PERMIT

P 515050-D

SEWAGE DISPOSAL SYSTEM HOWARD COUNTY HEALTH DEPARTMENT BUREAU OF ENVIRONMENTAL HEALTH 410-313-2640

SUBDIVISION Peacefields @ Cattail Creek LOT NUMBER 7 ADDRESS 15537 Cattail Oaks

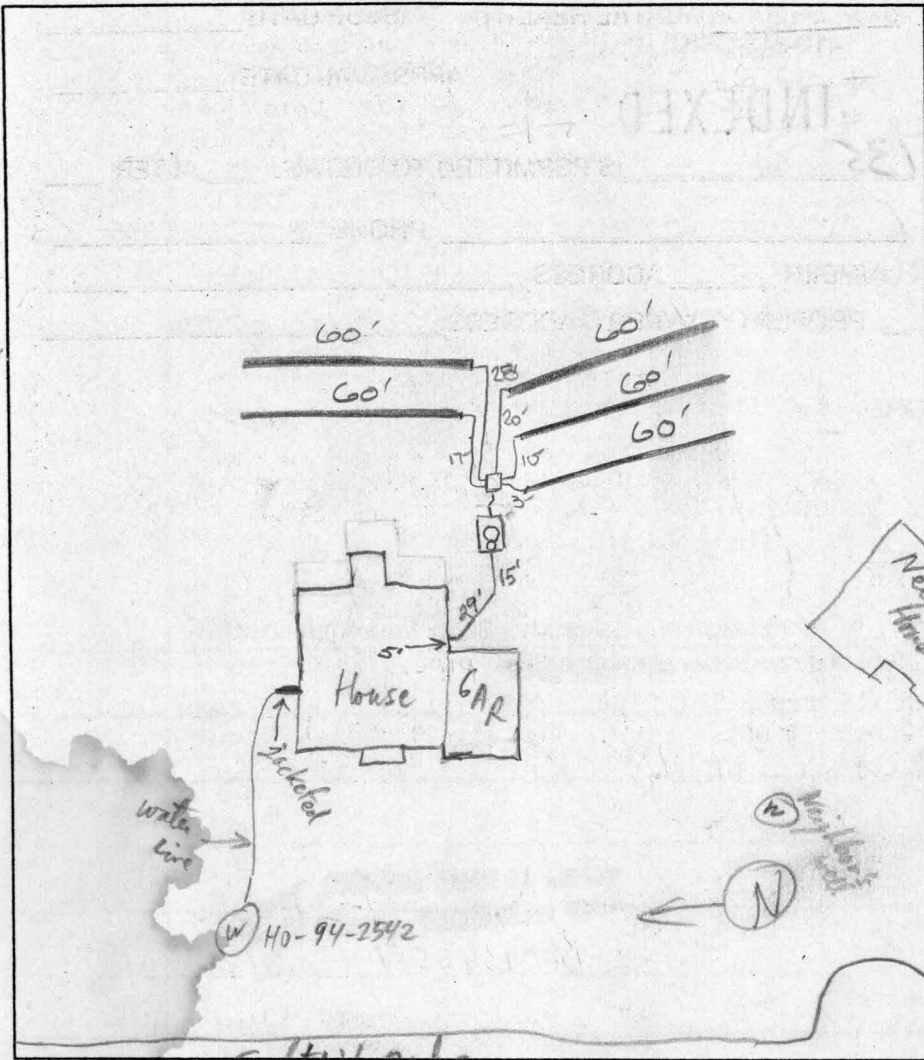
PRE-CONSTRUCTION INSPECTION: 5/11/01 Contractor will install as per B.P. plan, But he said he will try to keep trenches up higher to conserve area

INSPECTION COMMENTS: 5/14/01 FINAL INSP - OK to cover all work. Need cap on 6" cleardout on septic tank. DKO
